# Service Campaign Bulletin

## Torque Checks and Pipe Protection Sleeve Installation

Document Number	14 A 001
Campaign Reference	04E
Affected Vehicles	720S
Date Released	21 <sup>st</sup> June 2017
Version	1

## Airbrake Panel Instructions

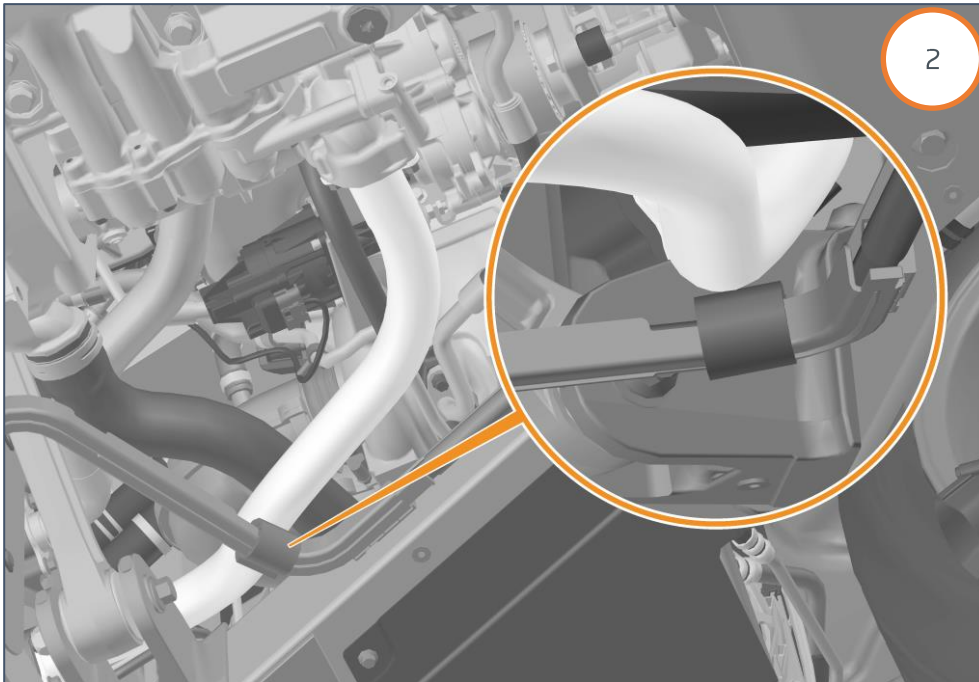
1. Turn the ignition ON.
2. Press the ACTIVE button to switch on the active dynamics panel.
3. Press the AERO button to raise the airbrake panel.
4. Check the torque (14Nm) of the airbrake panel mounting bolts M6 x 18 (1). If one or more are found loose, retorque to the correct value 14Nm.

## Rear Damper Instructions

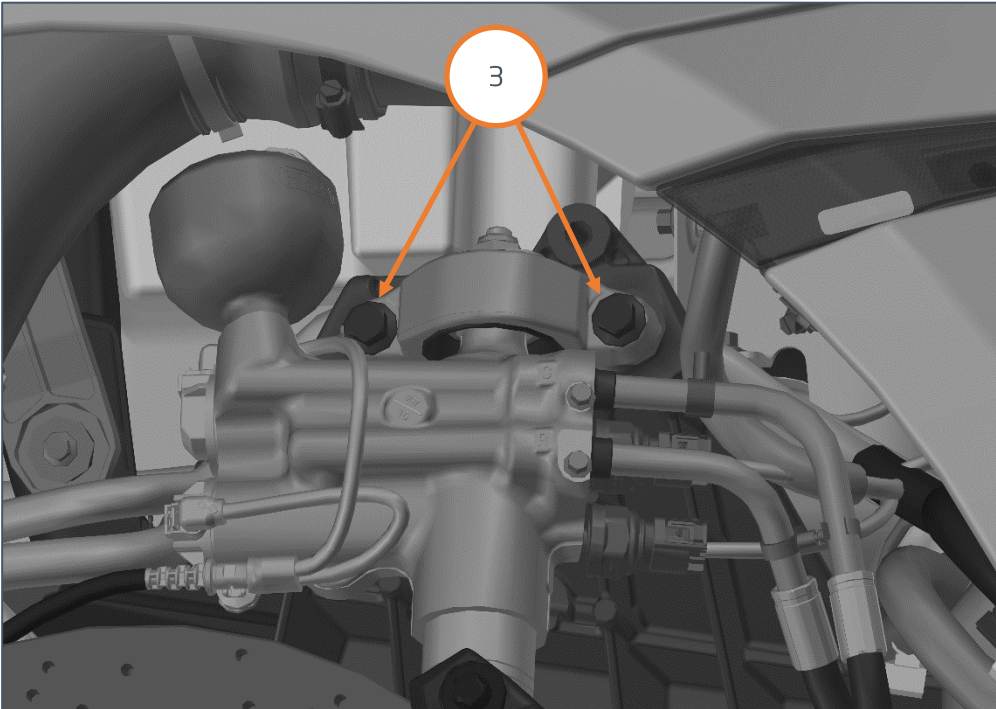
**Care Point:** Please ensure the torque check is completed on both left and right hand side.

1. Please refer to SIS "DA-RM-04B005-01-001 - Remove/Install wheel - Rear" to remove the rear wheels.
2. Please refer to SIS "DA-RM-03A076-02-001 - Remove/Install wheelarch liner - Rear" to remove the wheelarch liners.
3. Check the torque (57Nm) of the top bolts M10 x 40 (3). If one or more are found loose, retorque to the correct value 57Nm.
